Ref: KN590/05

1 March 2023

**Re: Development Application No DA2022/1164
34-35 South Steyne Manly
Objection to amended proposal**

Viewpoint 07

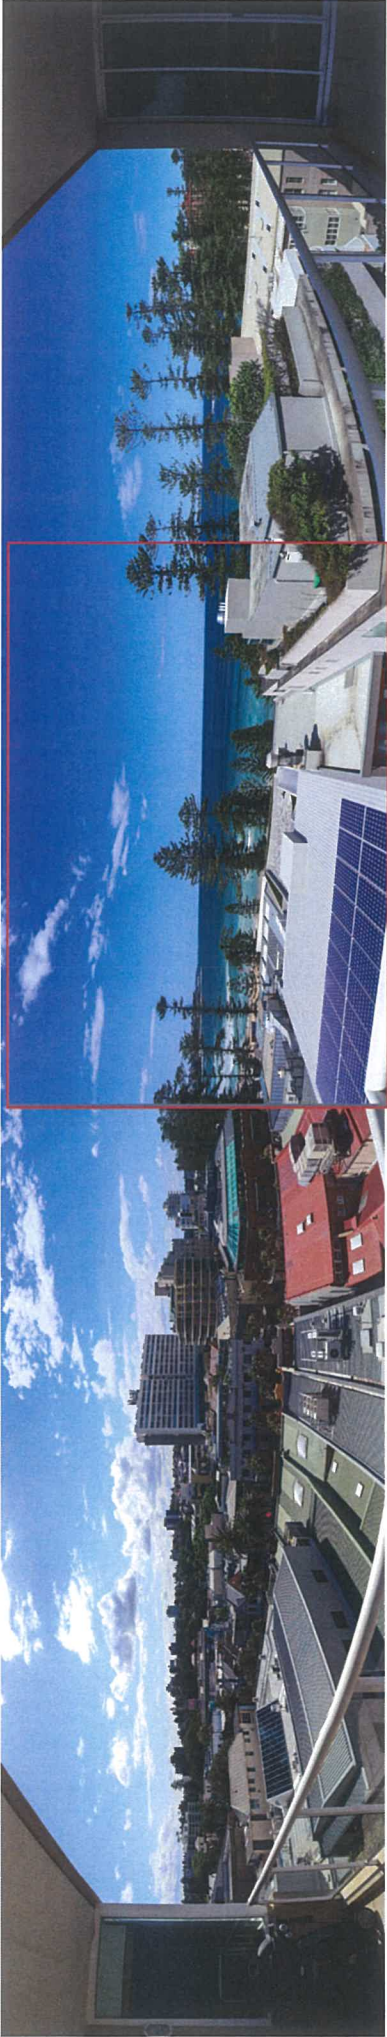
Balcony – loss of 100% of views of eastern footpath/promenade, lower portions of Norfolk Pines, Manly Beach and land and water interface at low and high tides as evident in Viewpoints 07 and 08.

Living Room – 100% loss of Manly Beach as detailed in Viewpoint 07 and 08. Distant views of Tasman Sea retained - impact devastating for the reasons detailed above.

Viewpoint 10

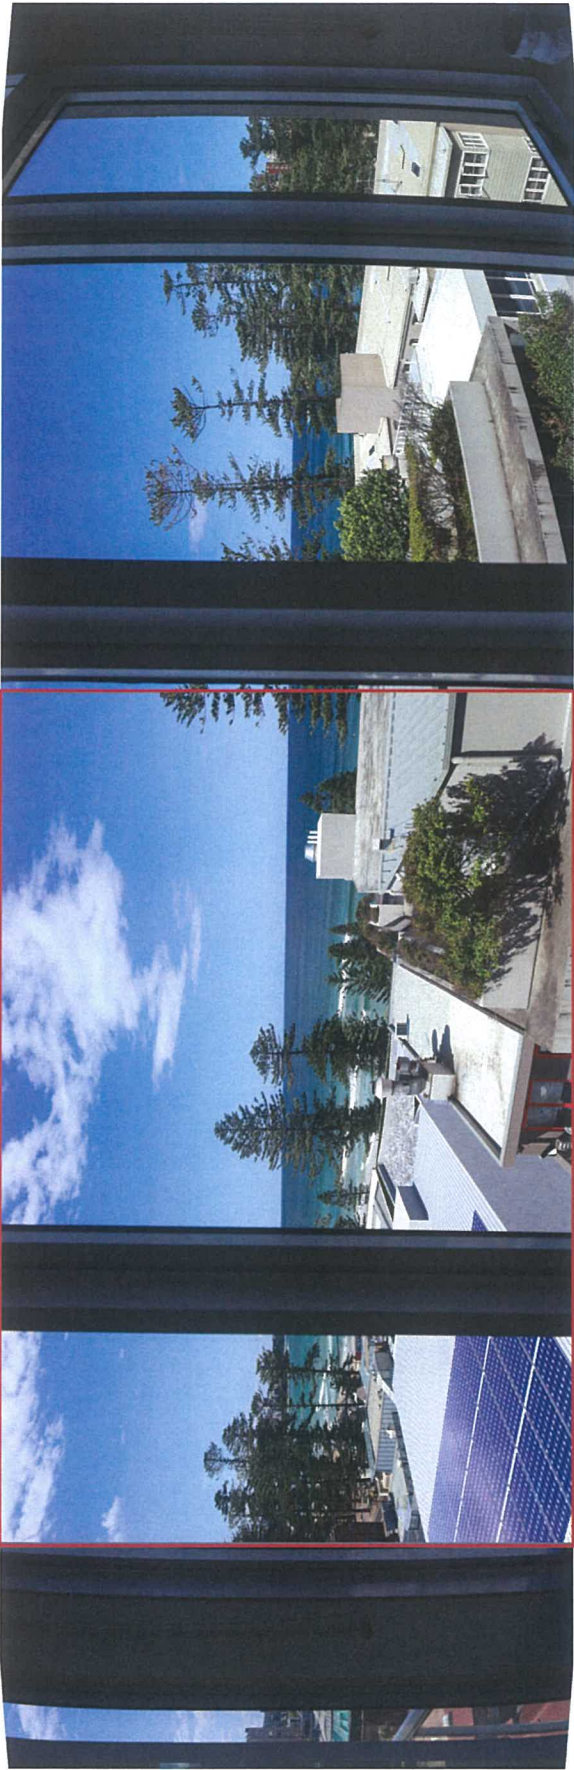
The View Loss Assessment, in particular Viewpoints 07, 08 and 10 confirm the view loss assessment undertaken in accordance with the planning principle in *Tenacity Consulting v. Warringah Council [2004] NSWLEC 140*, embodied in my objection of 17 August 2022, namely:-
